Office Action Summary

09/492,369

BLAHA, WILLIAM E.

DETAILED ACTION

FIG.3

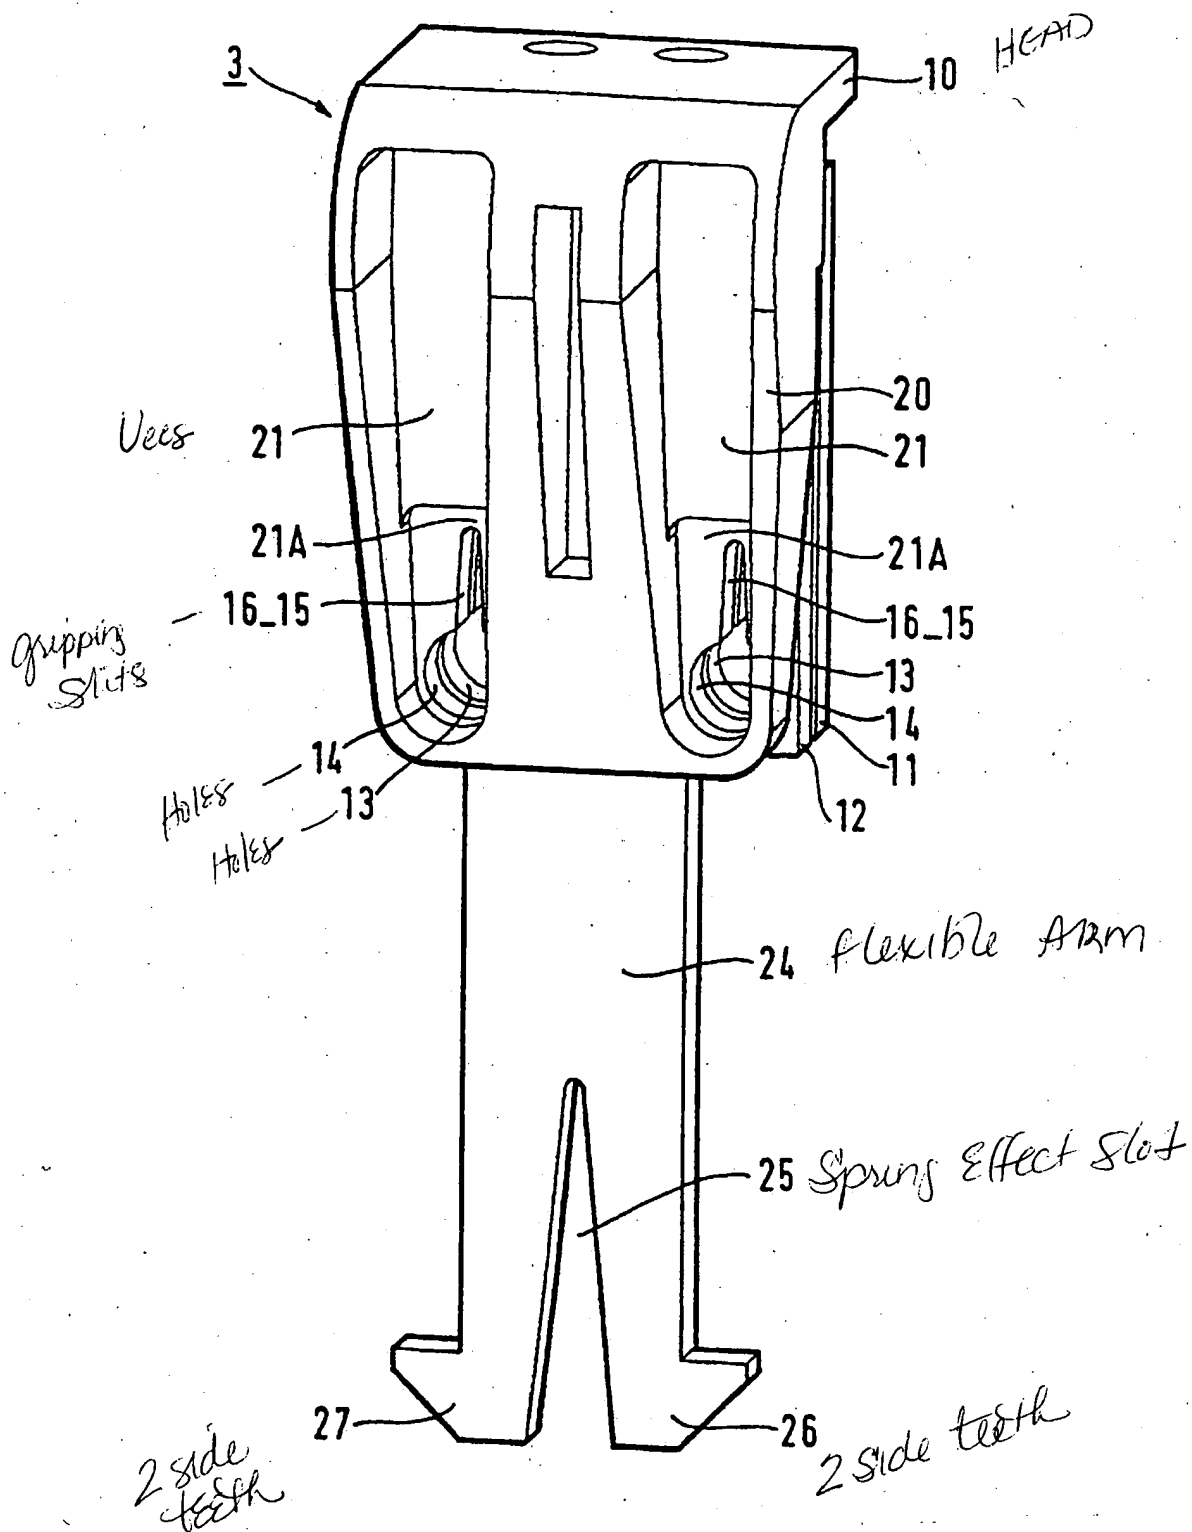
Regarding claim 1, Jacques discloses a wire connector joining two or more incoming wires (10), a housing (1), walls (Col. 4, line 46-49), cavity (4), openings (14), conductive clip extending through housing walls (see Attachment 2). Jacques does not disclose a clip having first and second retaining fingers. Benes et al teaches a clip having a first and second retaining fingers (34a & 34b). It would have been obvious to one of ordinary skill in the art at the time the invention was made to design the wire connector of Jacques with a conductive clip having first and second retaining fingers of Benes et al to allow the first finger to restrain the wires prior to insertions into their respective wire-terminating slots and a second finger to secure the wires after they have been inserted into the slots.

Regarding claim 2, Jacques discloses a conductive clip having a plurality of tines (see Attachment 2).

Regarding claim 3, Jacques discloses a two-part housing with base and cap (see Attachments 1 & 2).

Regarding claim 4, Jacques discloses a conductive clip with a plurality of finger forming a push-in connector (see Attachment 2).
